## **REMARKS/ARGUMENTS**

In response to the Examiner's first Office Action of November 29, 2005 the Applicant respectfully submits the accompanying Terminal Disclaimer with respect to USSN 10/760,200, Amendment to the specification, drawings and claims, and the below Remarks directed thereto.

FIG. 43

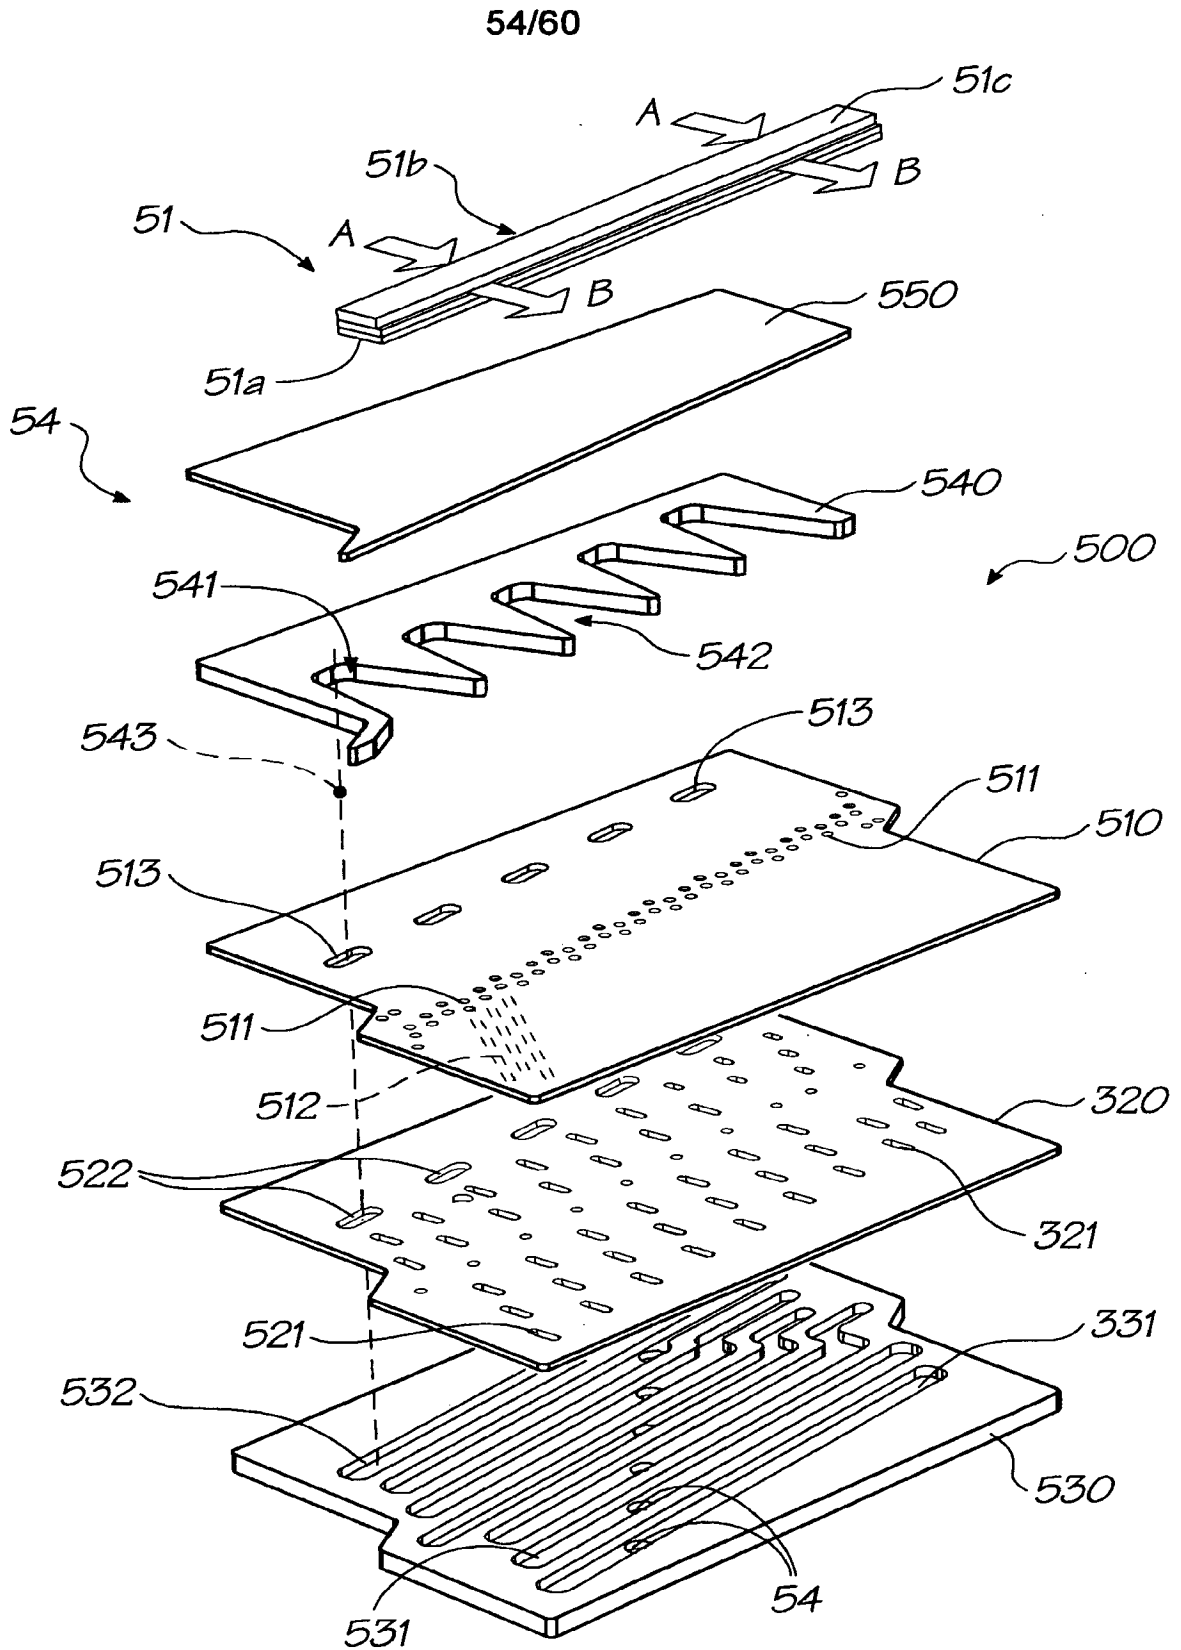
Fig. 43 is amended to include the reference sign "500", as is described at page 8, lines 23-31 of the present specification;

#### ***Regarding reference sign "500"***

It is respectfully submitted that the above-described amendment to Fig. 43 to insert the reference sign "500", provides the correction required by the Examiner.

A corrected Fig. 43 is enclosed.
